RE: **P.Z. 03-2020 Downtown Chesterfield (Wildhorse Village, LP)** An ordinance amending City of Chesterfield Ordinance 3023 to amend the legal description and development criteria for an existing PC&R Planned Commercial and Residence District for a 99.6 acre tract of land located west and southwest of the intersection of U.S. Highway 40/I-64 and Chesterfield Parkway West (18T620185, 18T620206, 18T620053, 18T630272, 18T630195, 18T640248, 18T640260, 18T640271, 18T620174, 18T640183, 18S410240, 18S410206, 18S430259, 18S430282, 18T640336, 17T320158, 18T640237, 18T640259, 18T620064, 17T320169).

Planning Commission Staff Report

Petition: **P.Z. 03-2020 Downtown Chesterfield (Wildhorse Village LP.)**: An ordinance amending City of Chesterfield Ordinance 3023 to amend the legal description and development criteria for an existing PC&R Planned Commercial and Residence District for a 99.6 acre tract of land located west and southwest of the intersection of U.S. Highway 40/I-64 and Chesterfield Parkway West (18T620185, 18T620206, 18T620053, 18T630272, 18T630195, 18T640248, 18T640260, 18T640271, 18T620174, 18T640183, 18S410240, 18S410206, 18S430259, 18S430282, 18T640336, 17T320158, 18T640237

WILDHORSE VILLAGE BUILDING SPACING ON LAKEFRONT ST

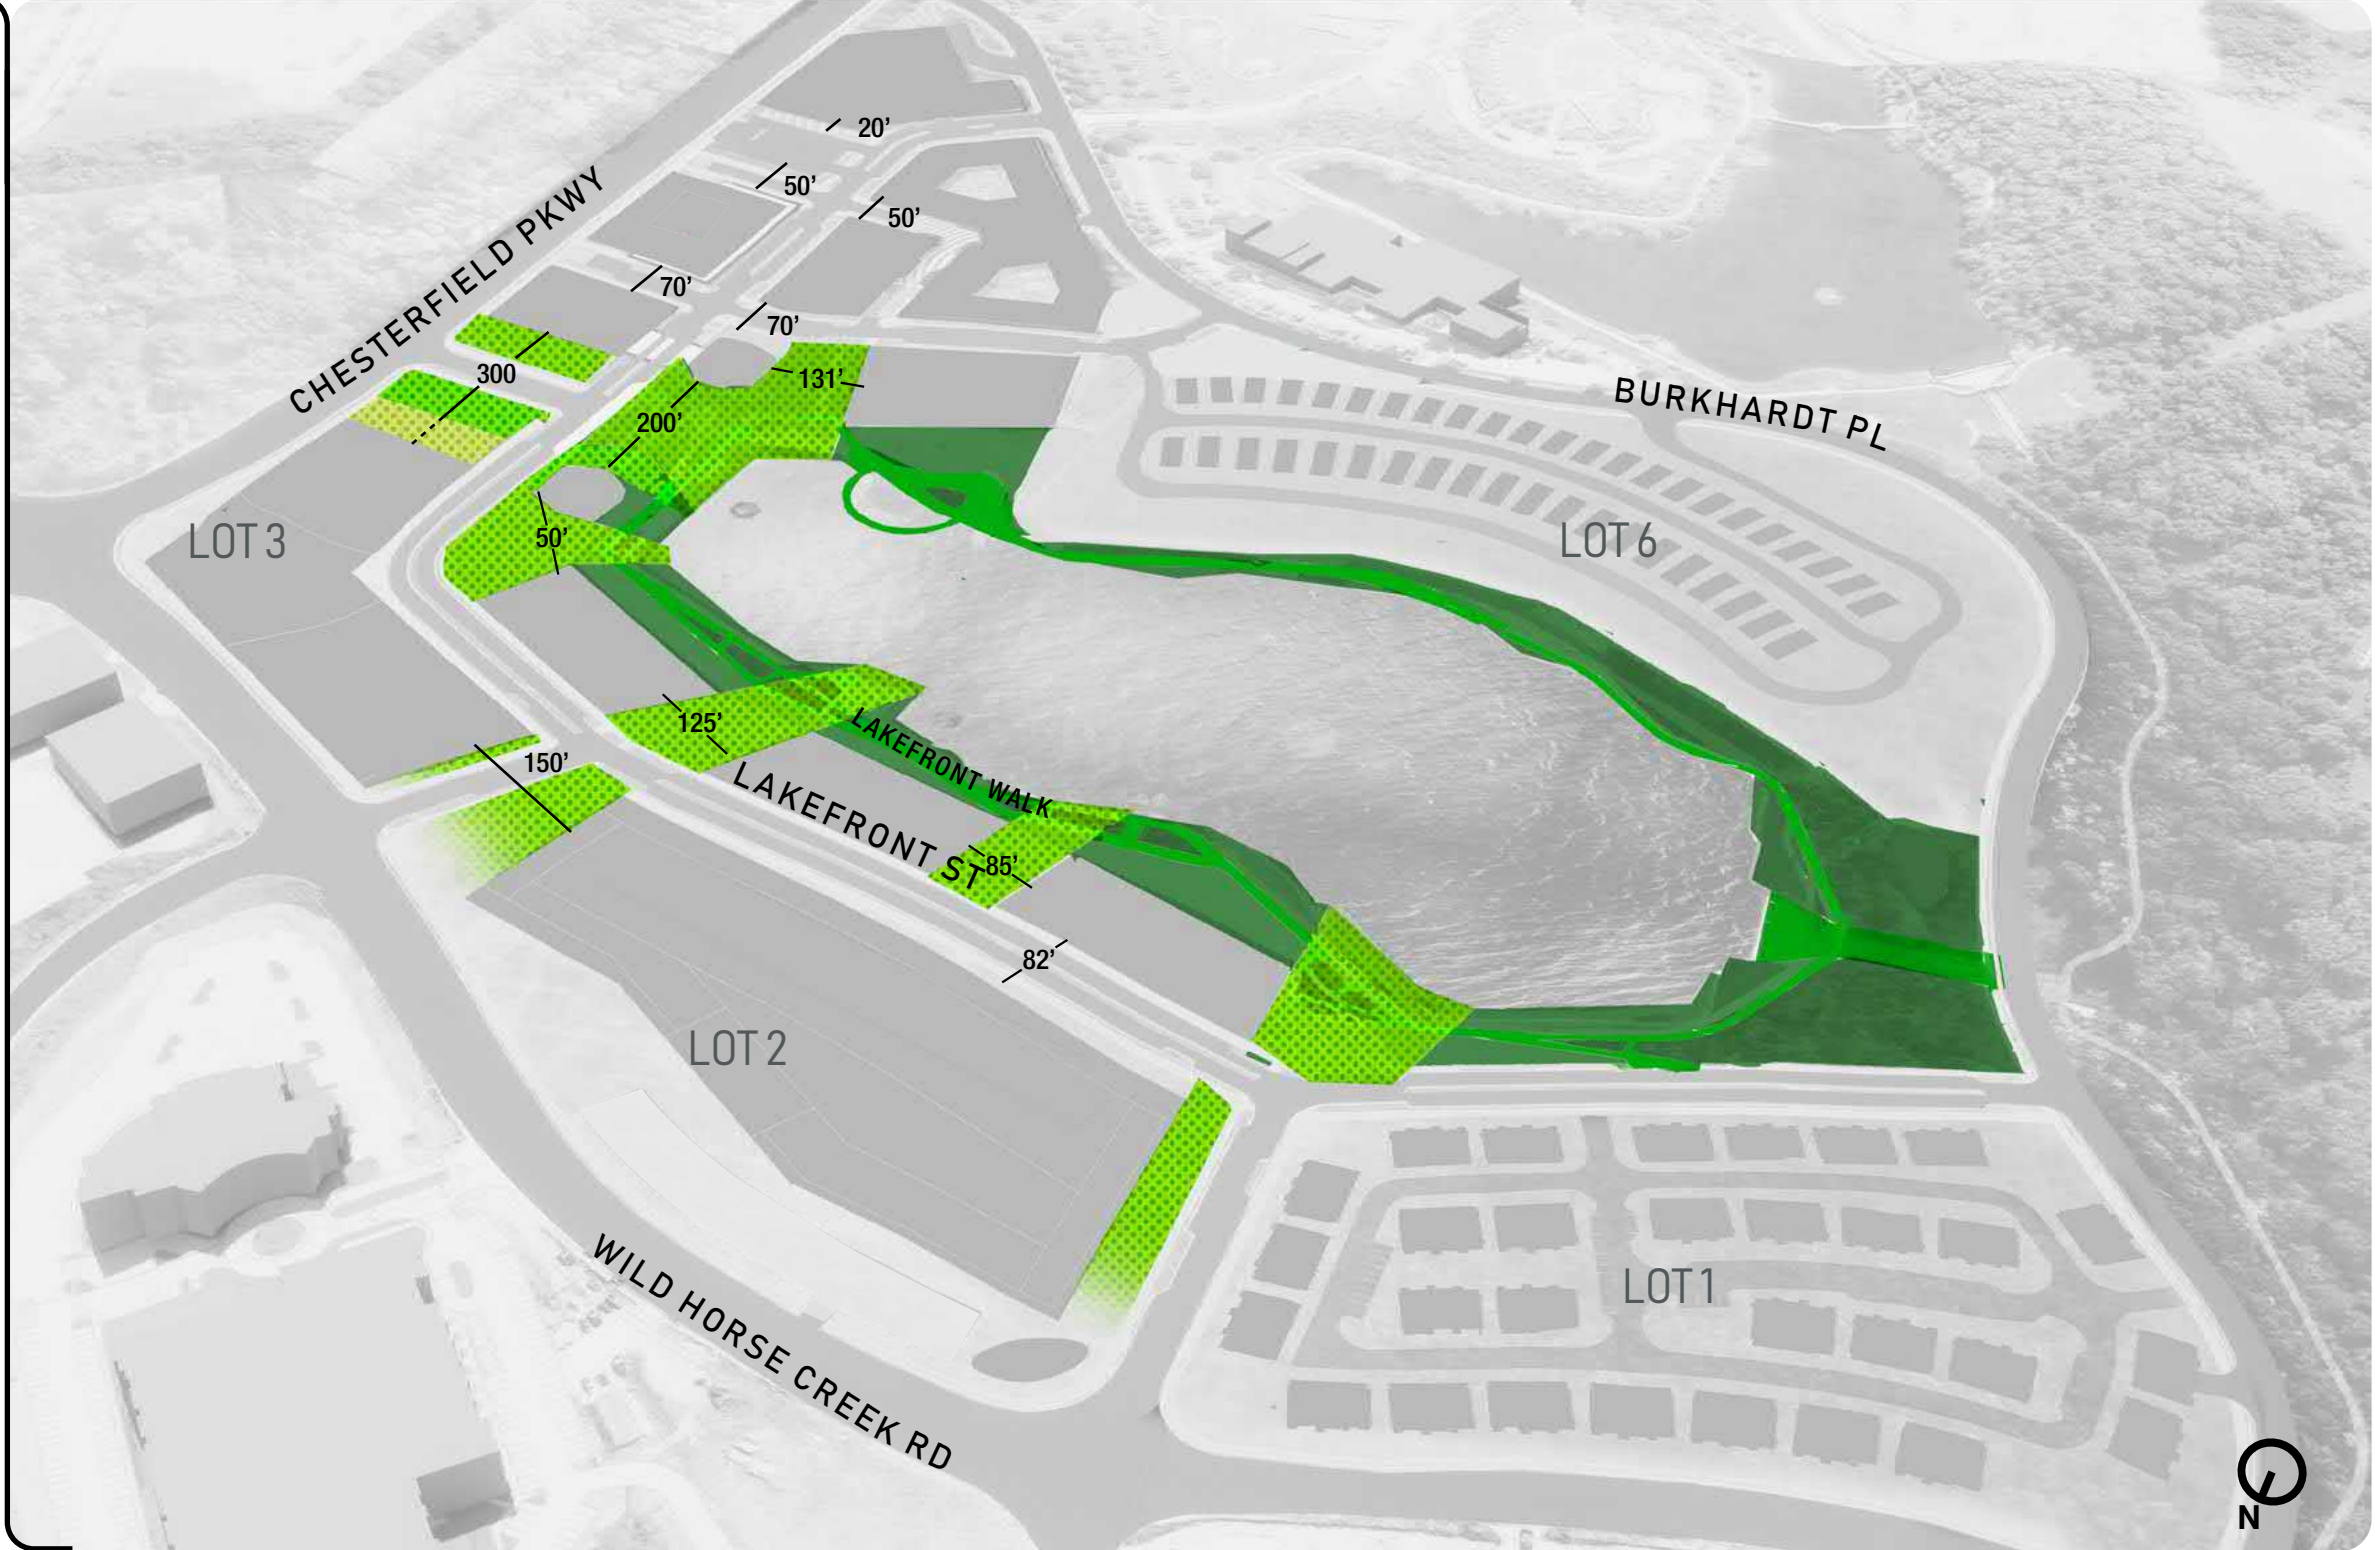
3. There was a statement from residents stating they would be supportive of the request to delete the requirement of (6-15) feet between detached buildings except for along the Lake Front Street. Provide additional information on the spacing of buildings along the Lake Front Street and the necessity to have the spacing requirement removed.

Response: In order to accommodate substantial topographical challenges within the site and to allow view corridors from Wild Horse Creek Rd., Chesterfield Parkway West and Lakefront Street, spacing in center areas needs to be increased to 125 feet. (see Building Spacing on Lakefront Street slide in the LJC Exhibit)
